UNITED STATES PATENT AND TRADEMARK OFFICE

APPLICATION NO.	FILING DATE	FIRST NAMED INVENTOR	ATTORNEY DOCKET NO.	CONFIRMATION NO.
10/813,067	03/31/2004	Steven T. Fink	244568US6YA	4640

Office Action Summary	Application No. 10/813,067	Applicant(s) FINK, STEVEN T.	
	Examiner Jeffrey Sharp	Art Unit 3677

DETAILED ACTION

US-5,332,443 to Chew

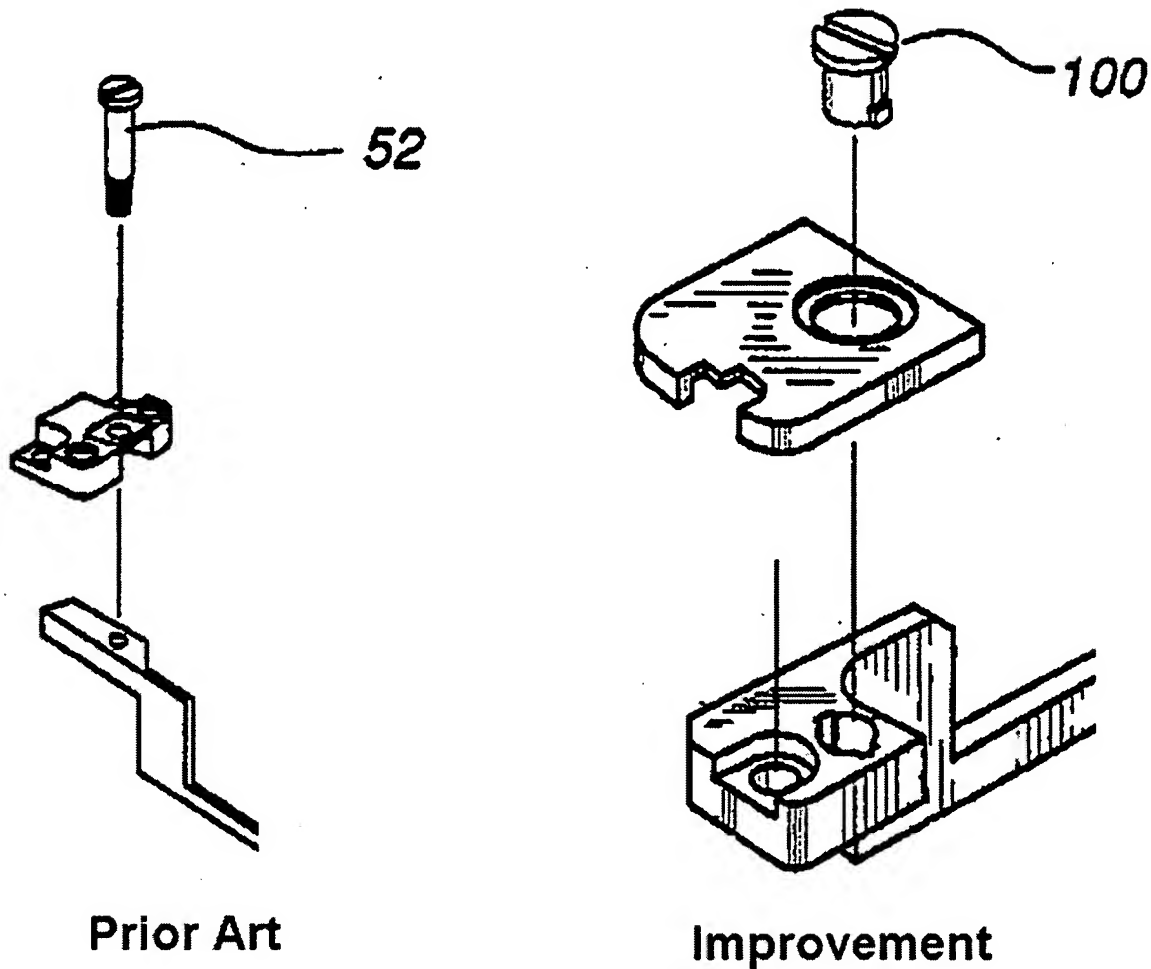
Applicant suggests that it is already known to connect a gas inject plate to an electrode plate via a bolt.

However, the prior art disclosed by Applicant fails to disclose expressly, a (quarter-turn or the like) fastener having a stem, head and a locking pin to fix a gas inject plate to an electrode plate.

Chew suggests and/or makes obvious that bolts (52) within process chambers may advantageously replace bolts with quarter-turn fasteners (100) or the like. Refer to Chew Col. 4 line 59-Col. 5 line 3, Col. 5 lines 21-33, and Col. 5 line 60-Col. 6 line 3. Chew further makes obvious that a cover plate (104) is only needed to protect those fasteners (80, 90, 82, 84, 92) not made with a resistant material (e.g., ceramic, silicon), but are instead made of metal which would *"over time oxidize and generate unwanted particles within the thermal processing chamber environment"*. Chew expressly discloses the fact that fasteners being exposed with no cover plate (e.g., quarter-turn fastener 100) are to be made from a resistant material.

Therefore, at the time of invention, it would have been obvious to one of ordinary skill in the art, to modify the prior art plasma process chamber assembly disclosed by Applicant (Figure 5), by advantageously replacing the bolt with a (broadly) quarter turn fastener or the like, in order to "allow the [quarter-turn] screw 100, along with the cover plate 96, to be removed easily" and to allow rapid disassembly of the two plate components.
